Subject: **MINIMIZING HORIZONTAL NOISE**

Model: **PVM-8040/8041Q/8043MD/8044Q**

Serial No: **2,000,001 AND HIGHER**

Figure 1

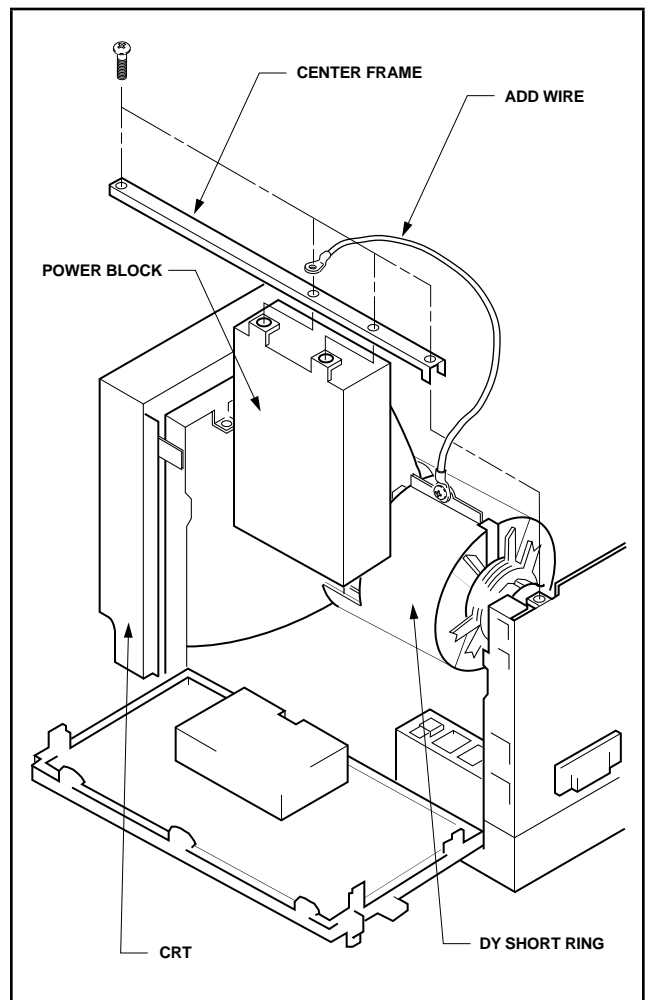
A horizontal noise stripe in the video picture may be the result of an electrical discharge. To correct this condition, a new CRT socket is now available as a replacement part. A complete modification procedure is described below.

Former	➔	New
CRT Socket 1-526-958-41		CRT Socket 1-251-244-11

MODIFICATION PROCEDURE
CA Board, Solder Side
(See Figure 1.)

1. Replace CRT socket with a new one.
2. Connect G1 terminal to GND.
3. Remove R705 and C702.
4. Solder a 15mm jumper on land vacated by R705.
5. Use RTV silicon glue (part no. 7-322-065-19) to secure the CRT socket to the CRT.
6. Add a wire connecting the DY short ring to the center frame that holds the power block as shown.
7. Tack-solder a 1MΩ resistor between CN507-6 and CN507-8 on the D board.
